RE: 140 Haverhill Street, Amended Plan #2
DEP File # 090-1387 Response to Peer Review Comments

Please accept this letter and the attached plans as a response to the review comments provided by Horsley Whitten Group in a letter dated February 17, 2025. Our responses to comments are located below. Comments that did not require any response are not included.

Each of the stormwater structures listed above is shown on a plan attached as Attachment A.

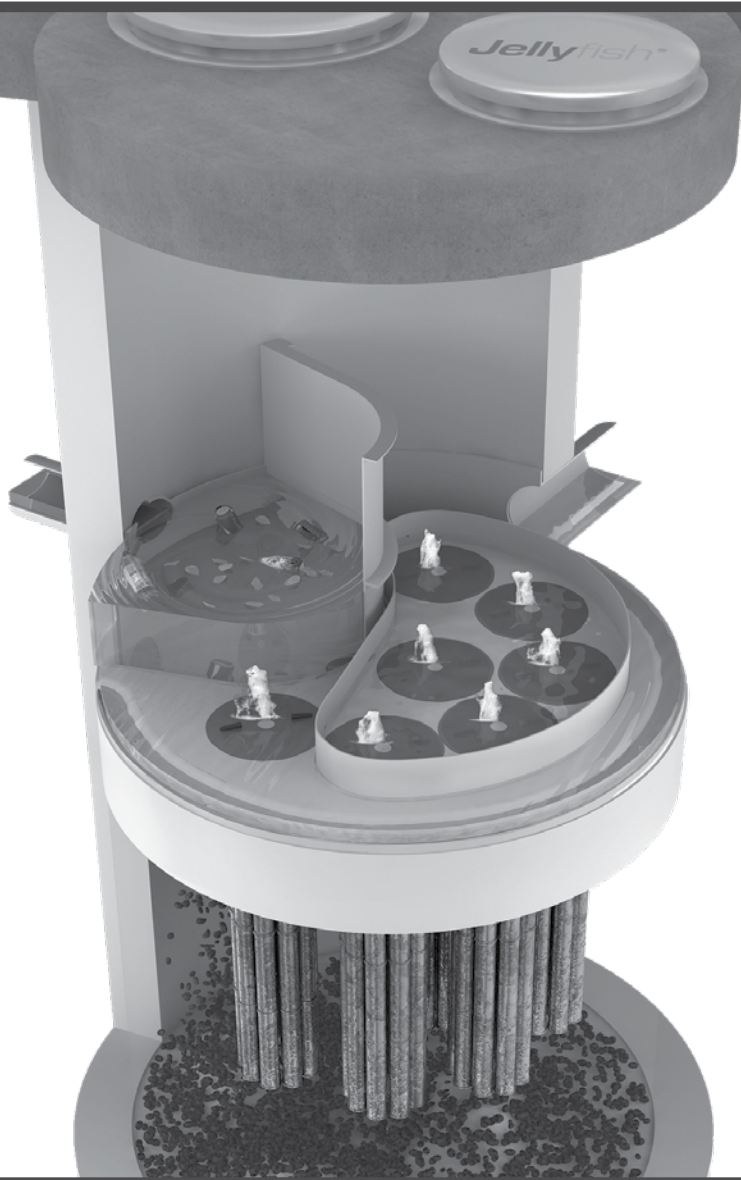
- i. The Applicant has included a simple sketch with the O&M Plan. However, the sketch needs to be updated to correlate to the amended design.

The sketch has been revised
